Community Development Authority MEETING AGENDA

CITY OF NEW BERLIN
DEPARTMENT OF COMMUNITY DEVELOPMENT
COMMUNITY DEVELOPMENT AUTHORITY STAFF REPORT

Colin Meisel with Ruekert Mielke, Inc. / 1-Lot Certified Survey Map
17100 W. Ryerson Road and 2940 S. Calhoun Road

D.R.C. RECOMMENDATION #1: Table the Use, Site and Architecture application for DreamPak located at 17100 W. Ryerson Road subject to the application, plans on file and the following reasons:

SHEET: C3.0

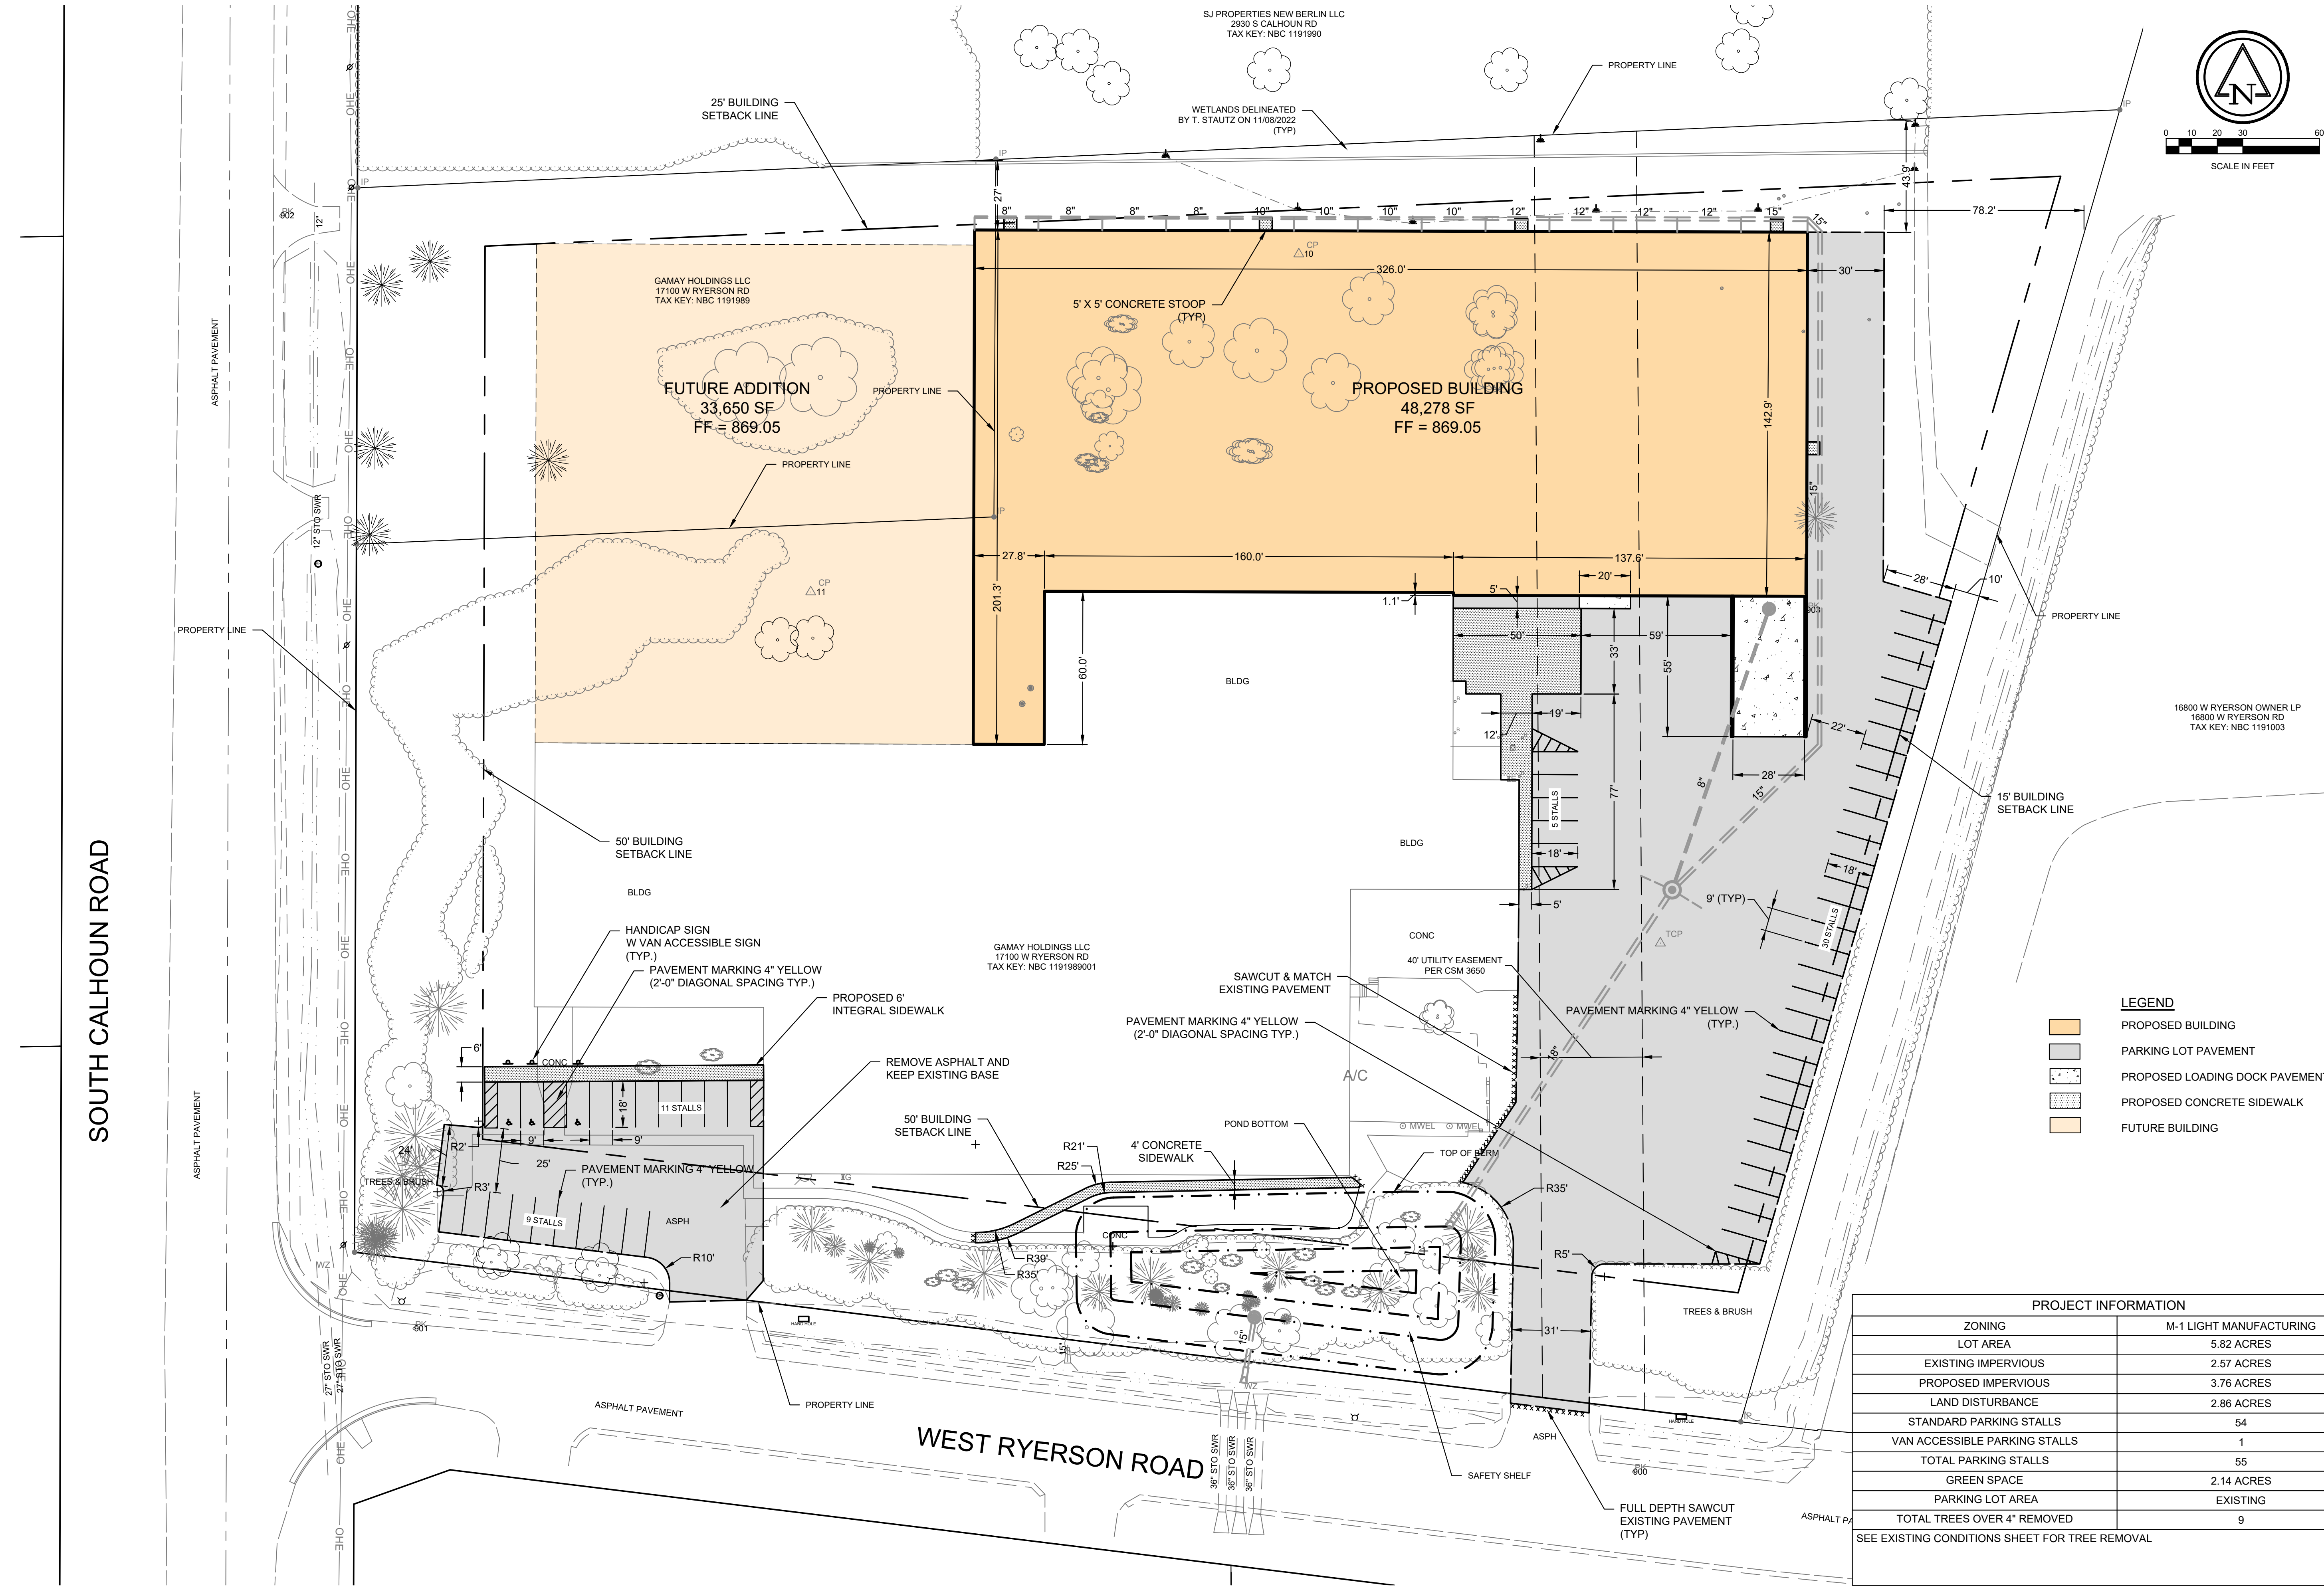
- c. Civil plans shall be revised to show proposed property lines after acceptance of 1-lot CSM, see File #: LD-2301013.
- d. Sheet C3.0 shall be revised to show current number of parking stalls, including parking calculations.

- e. Sheet C4.0 shall be revised to show lot coverage data after acceptance of 1-lot CSM, see File #: LD-2301013.
- f. Applicant shall comply with the tree replacement schedule outlined in §275-54B(6) of the Zoning Code, or pay the City the remainder of the balance to be placed in the landscaping account to plant landscaping elsewhere within the City. Provide information on the condition of the trees to be removed in the table on Sheet C3.0.
